CLINTON CITY PLANNING COMMISSION AGENDA ITEM

<p>SUBJECT: 7:10 p.m. – SITE PLAN REVIEW - Review and action upon a request from JEA Senior Living represented by Rachel Rudiger for a site plan and architectural review and possible approval for the Clinton Alzheimer Special Care Center to be located at 1404 North on the east side of 2000 West.</p>	<p>AGENDA ITEM: 1</p>
<p>PETITIONER: JEA Senior Living represented by Rachel Rudiger</p>	<p>MEETING DATE: May 19, 2015</p>
<p>ORDINANCE REFERENCES: Zoning Ordinance</p> <ul style="list-style-type: none"> ▪ 28-3-10 Site Plan and Architectural Approval ▪ 28-4-4(5) and contradiction with 28-4-5(13) ▪ 28-4-18 Parking Lot Landscaping ▪ Chapter 19 Performance Standard Zone ▪ Chapter 20 Central Business District Design Standards 	<p>ROLL CALL VOTE: X YES NO</p>
<p>BACKGROUND:</p> <ul style="list-style-type: none"> ▪ This use was originally set for 2050 N on the east side of 1800 N however the site was too small. ▪ This site is well suited to this use the structure is architecturally pleasing as well as the proposed site development. An issue comes to rise when evaluating the architecture in accordance with Chapter 20. Reviewing by section: <ul styl

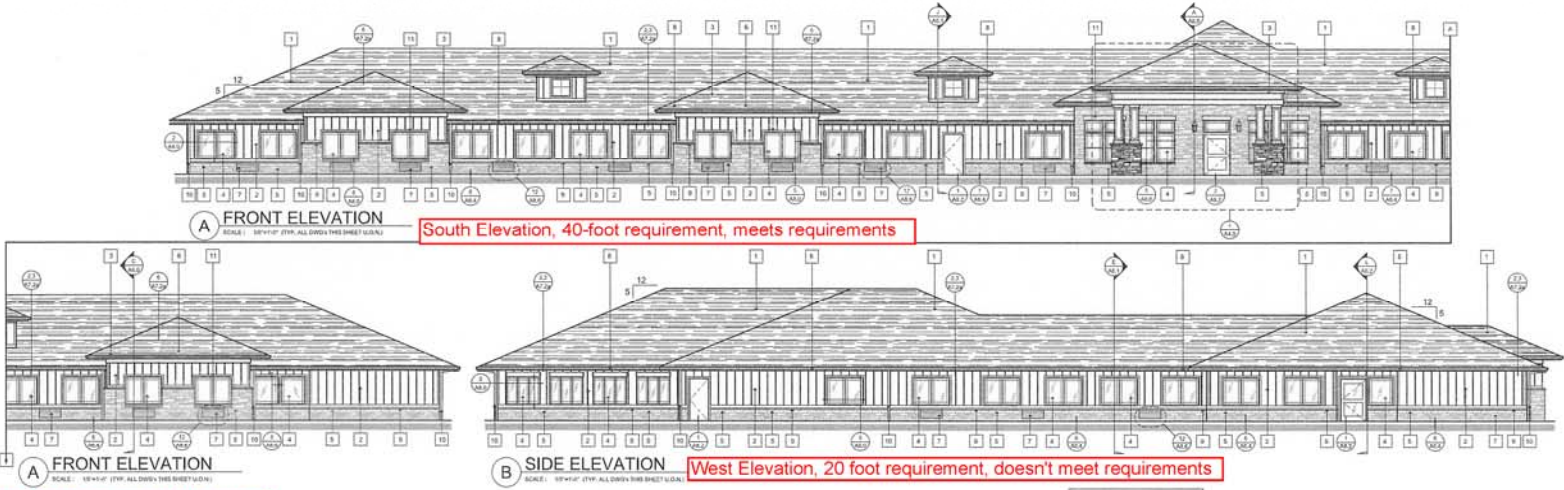
South Elevation, 40-foot requirement, meets requirements

West Elevation, 20 foot requirement, doesn't meet requirements

Northwest Elevation

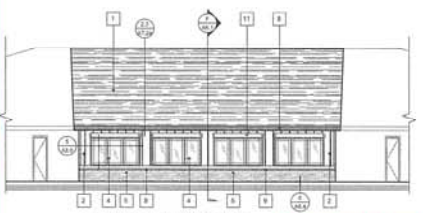
• **Roof Line Length.** For sides of the building facing a public street, roof lines shall vary in depth, shape or dimension every twenty (20) feet. For sides of the building which do not face a public street, roof lines shall vary in depth, shape or dimension every forty (40) feet. The change in depth, shape or dimension must run the length of the changed roof line.

• **Facade Length.** Facades lengths shall vary in depth, shape or dimension every twenty (20) feet at a minimum depth of twenty four (24) inches. For sides of the building which do not face a public street, facades shall vary in depth, shape or dimension every forty (40) feet. The change in depth, shape or dimension must run the length of the changed facade length.

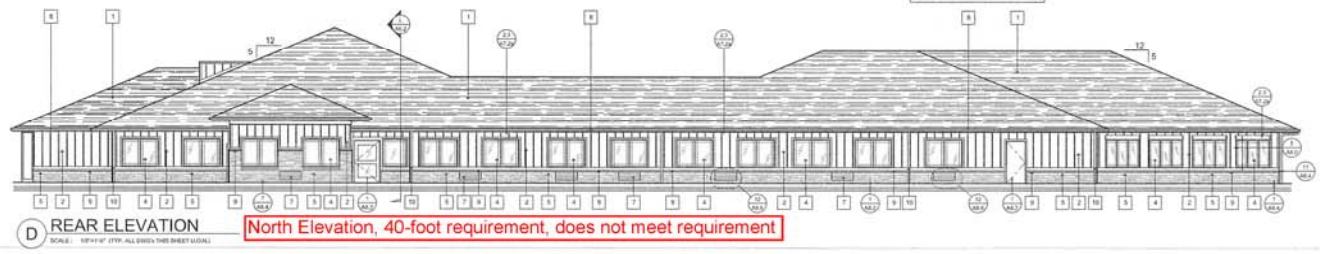
North Elevation, 40-foot requirement, does not meet requirement
